KC Custom Homes

Re: 2058 NW O'Brien Rd  
Lot 144, Estates of Woodside Ridge  
Lee's Summit, MO  
Permit # PRRES20222996

Apex Engineers Inc. observed the house under construction at the above-referenced address. Our firm has been retained to address comments from the city rough-in inspection. For the purposes of this report, the house will be referred to as facing south.

Figure 1.0 – Kicker Connection Detail

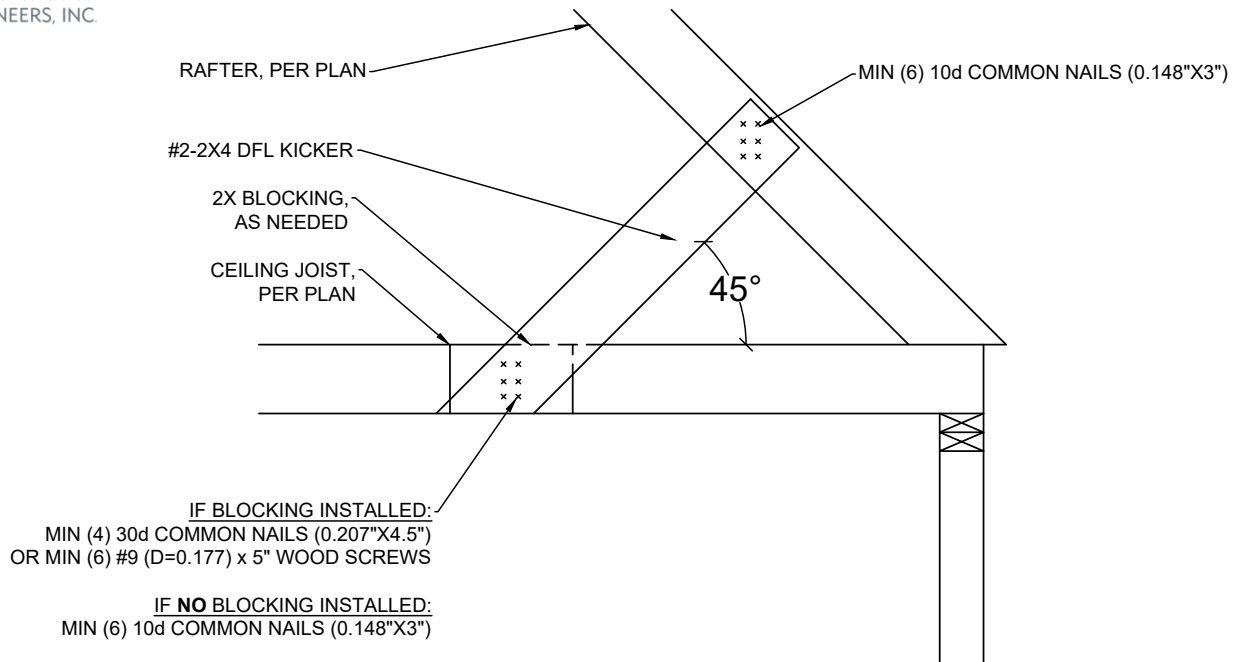
6. *Have engineer address rafters landing on 2x4s on edge and connection to the joists in bed 2.*
  - #2-2x4 kickers shall be installed at every heel joist connection where the rafter and ceiling joist are not face-nailed. Fasten the kicker to the rafter and ceiling joist per figure 1.0. Install solid blocking between rafters. Install solid blocking as needed for kicker attachment.
